# SERVICE BULLETIN No. BB/48, BB-S/9, rev. 1

1. WITH REFERENCE TO: All hot air balloons Kubicek S/N 800-1280, except those equipped by single

line deflation system.

## **Example of discoloured lines**

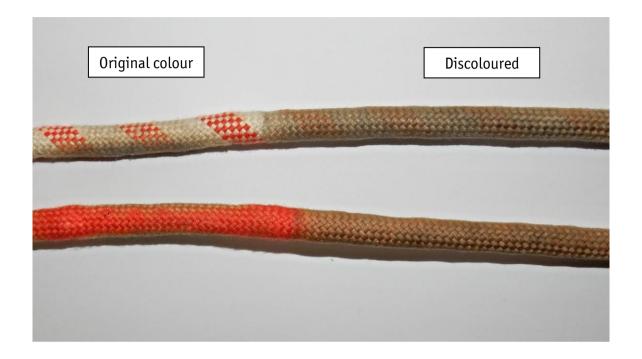
**2. REASON:** Discolouration of deflation system control lines has occurred which could impair

distinguishable. If discolouration occurs (see the photo on the next page), the

PRIOR TO THE NEXT FLIGHT - if the lines are non-distinguishable (as illustrated

on the photo bellow)

Here is an example of a red and white line and red line with significant discolouration than disables a simple and unmistakable distinction. Such lines need to be replaced.

affected control line(s) must be replaced with a new line.

**8. PROCESS:** If necessary, replace the control lines according to the instructions provided in the

Maintenance Manual (B.2202).
